September 23, 2022
HDR Project #10346973
Town of Cortlandt

**Re: Homeland Towers / New York SMSA Limited Partnership d/b/a Verizon Wireless
Proposed Installation of a Wireless Telecommunications Facility
52 Montrose Station Road, Town of Cortlandt, Westchester County, NY**

This Tech Memo was prepared for the Town Planning Board to assist in its ongoing Site Plan, SEQRA, and Special Use Permit reviews for the proposed new wireless telecommunications facility. The need for variances, such as from the ZBA for setback distances, should be confirmed as the applicant has stated its current design does not require variances. HDR understands that required permits and approvals will be confirmed by the Town. The Tech Memo includes a general assessment of the application (including technical information from the applicants), focusing on issues related to facility operation, capacity/coverage needs, and conformance with electromagnetic radiation hazard criteria. In addition, potential aesthetic impacts and other aspects of the proposed installation are discussed. This review consists of an analysis of the initial and supplemental materials provided by the applicant as of the date of this Te

Overall Site Plan (Drawing Z3 Detail 1, 8-10-22)

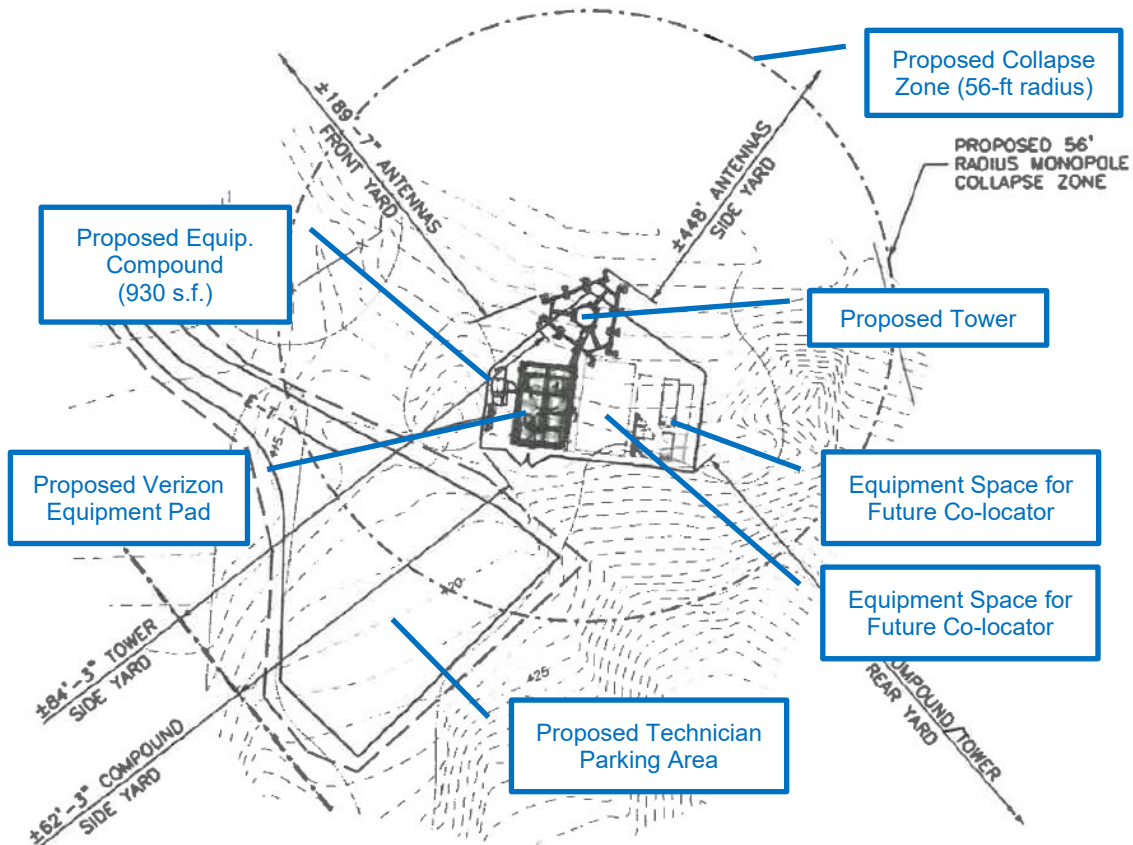
A 930 square foot equipment compound surrounded by an 8-ft tall chain-link fence with privacy slats at the base of the tower is proposed. The compound has space for three ± 150 -square foot ground-based equipment pads which can accommodate Verizon's and two future co-located carriers' ground-based equipment. A new access driveway from the end of Montrose Station Road roughly following the western edge of the parcel is proposed to facilitate construction and future technician access to the facility. A small parking / turnaround area for maintenance vehicles is included southwest of the equipment compounds and abutting the property boundary. Tree removal is proposed to accommodate the construction of the access drive and compound with a total of 19 trees proposed for removal. A preliminary tree removal plan is included as Drawing Z12 in the 8-10-2022 drawing set. Details on site grading were not provided.

access drive shown on sheet Z3 overlap with areas identified as rock outcrops on the applicant's survey shown on sheet Z11. Rock removal plans and/or blasting plans have not been noted by the applicant. Final means and methods for foundation work, grading, and other construction will be provided during the building permit process should the project obtain the necessary approvals from the Planning Board.

Compound Layout (Drawing Z4, 8-10-22) This drawing also depicts the antenna plan.

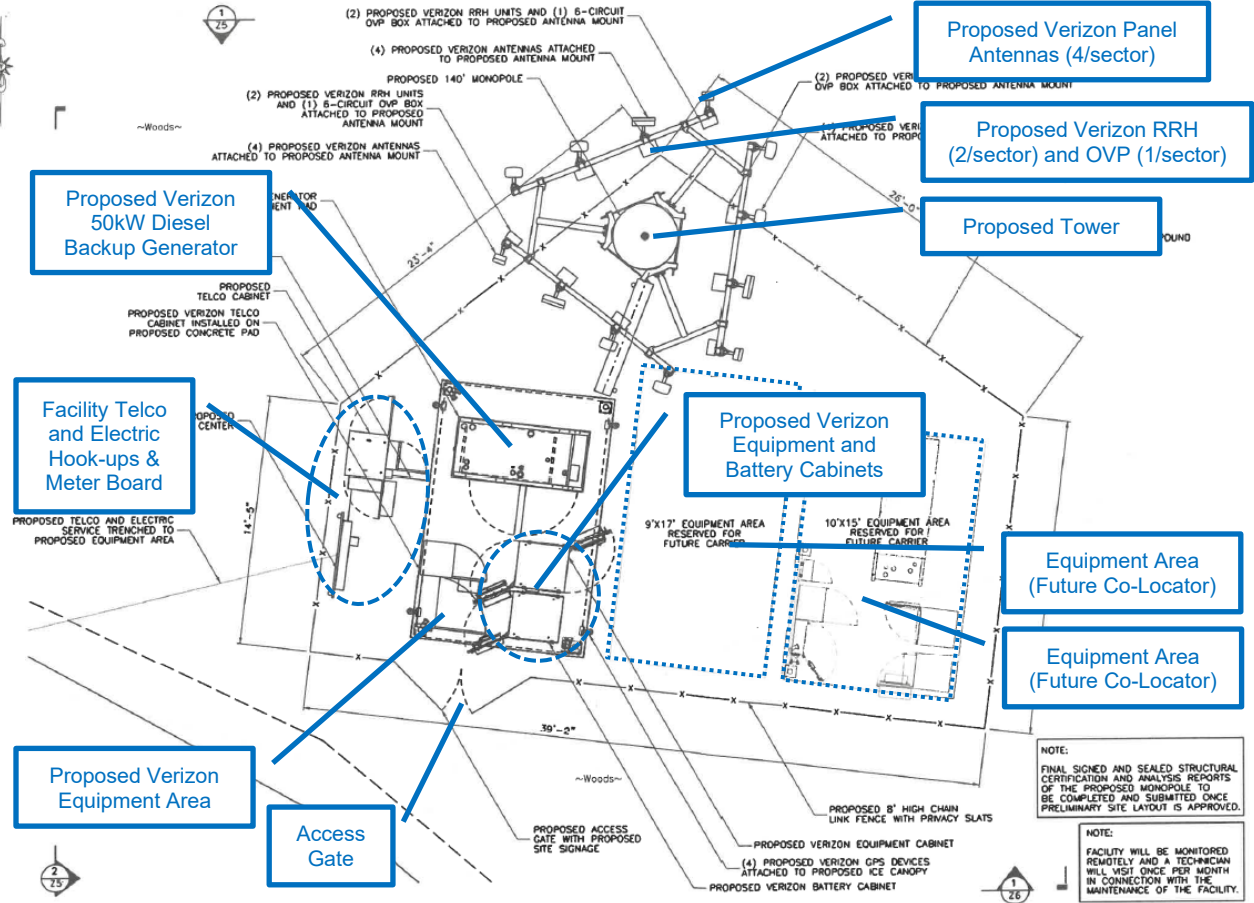
- §277-6E(1)(q): The applicant has not provided its "proposed tower maintenance and inspection procedures and related system of records" beyond a note on drawing Z4 saying that the tower will be monitored remotely and visited monthly by a technician. Additional information (maintenance plan and checklists) can be furnished as a condition (should the site plan and special use permit approvals be granted by the Planning Board).

Existing and Proposed 750 MHz LTE Coverage (C Squared Supplemental Filing, August 2022).
 Annotations added by HDR.

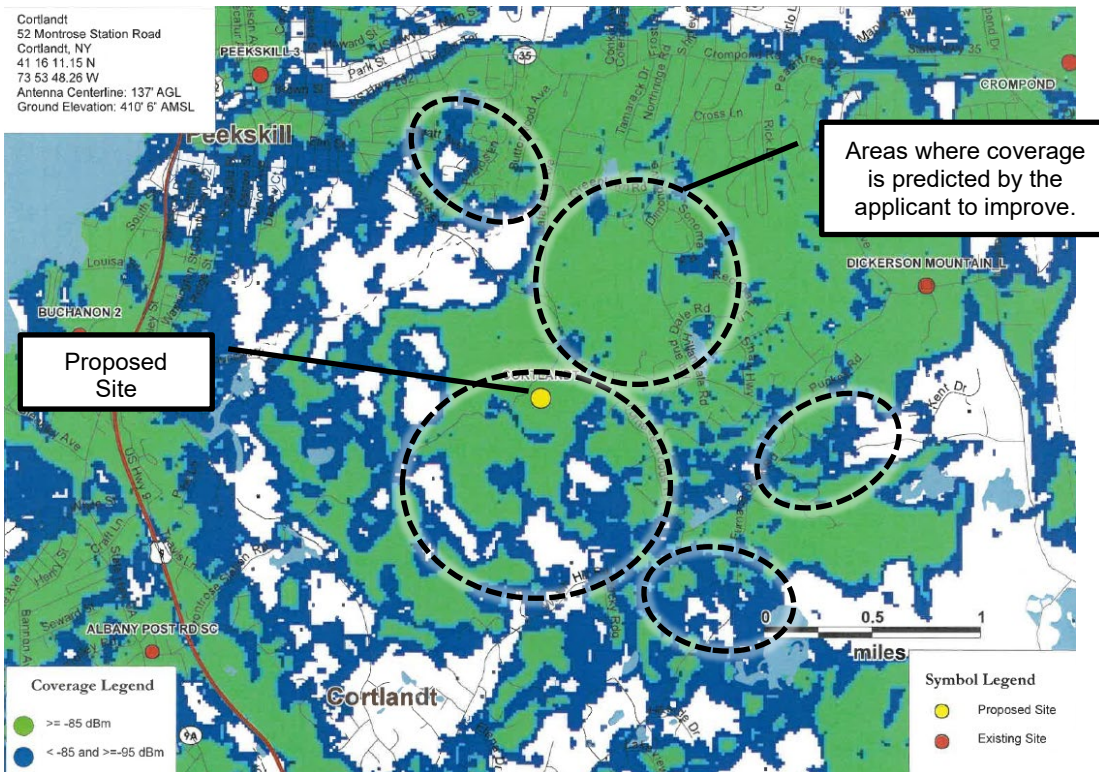
As previously noted, the applicant has stated that the proposed tower is intended to fill a coverage gap in its network. The following images are taken from predicted coverage maps updated to reflect current (as of August, 2022) network conditions and included in C Squared's August 2022 responsive filing. The figures present the current and proposed 750 MHz coverages, which provides a more optimistic view of network coverage as the signal tends to propagate further than higher frequencies and therefore higher frequency bands would have a smaller footprint. Updated coverage maps for other, higher frequencies were not provided by the applicant citing the fact that the coverages would be smaller.

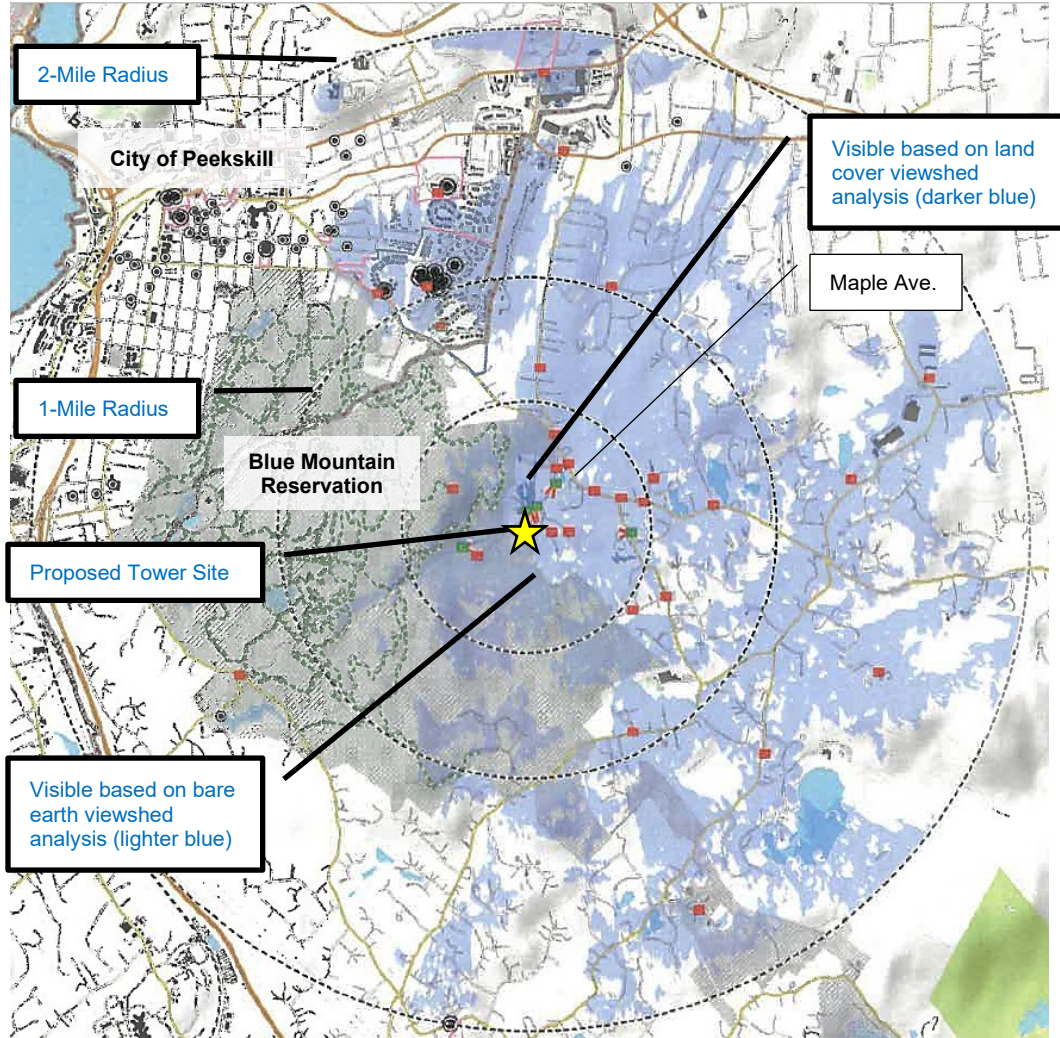
Based on the viewshed maps above, it appears that visual impacts resulting from the proposed tower are most likely to occur within approximately 0.5 miles of the tower and limited to the gas transmission right-of-way in Blue Mountain Reservation to the west; open spaces and residential parcels to the north and in the immediate vicinity of the proposed tower, and open spaces along Furnace Woods Road in the vicinity of the intersection with Galloway Lane. Viewpoints visited during the balloon test are indicated above as color coded squares. Red indicates that the balloon was not visible and green indicates that visibility was confirmed. Additional discussion on the balloon test, photosimulations, and visual resources assessment is below; however, HDR notes that the visibility predicted below was generally confirmed in the field by Saratoga as well as HDR during the balloon test.

Figure C14 Saratoga VRA (2022) – Simulation of the proposed tower with a galvanized gray finish.

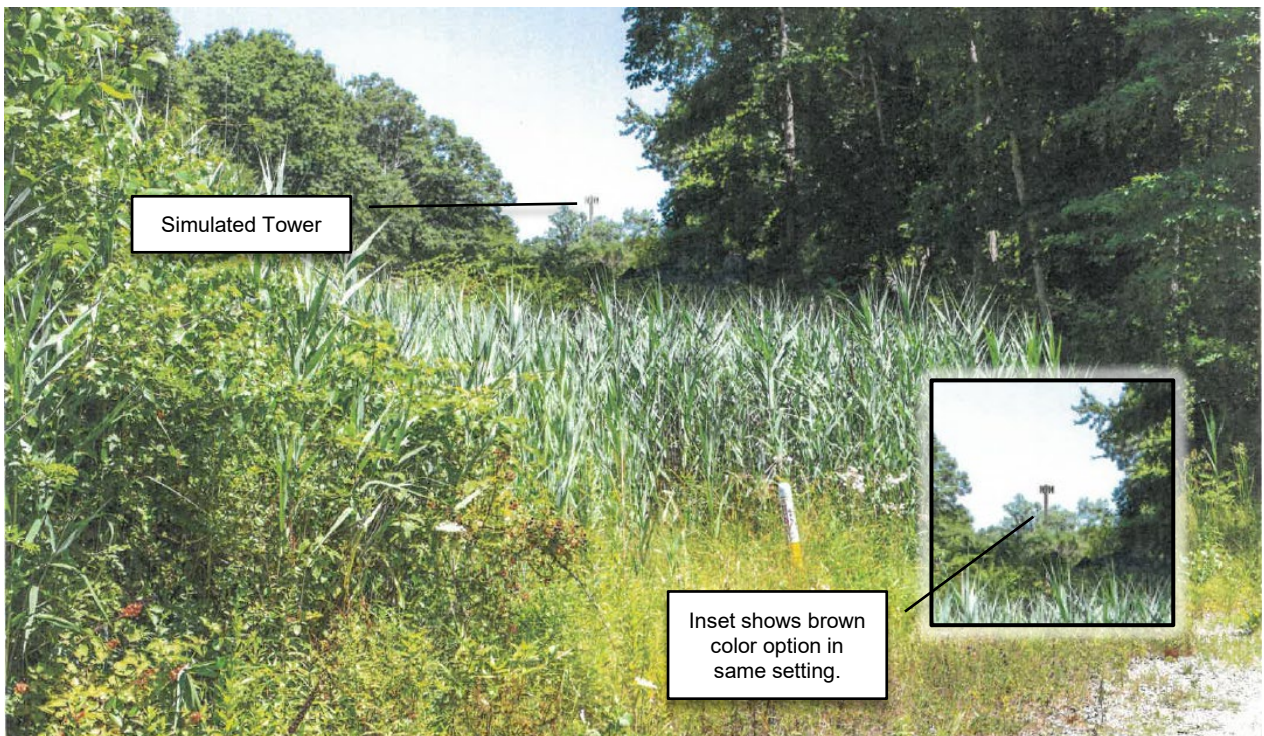
HDR visited areas in addition to the predetermined locations to confirm visibility. HDR noted that the balloon was visible at the intersection of a foot trail and a gas transmission main right of way within Blue Mountain Reservation approximately 1,500 feet away.
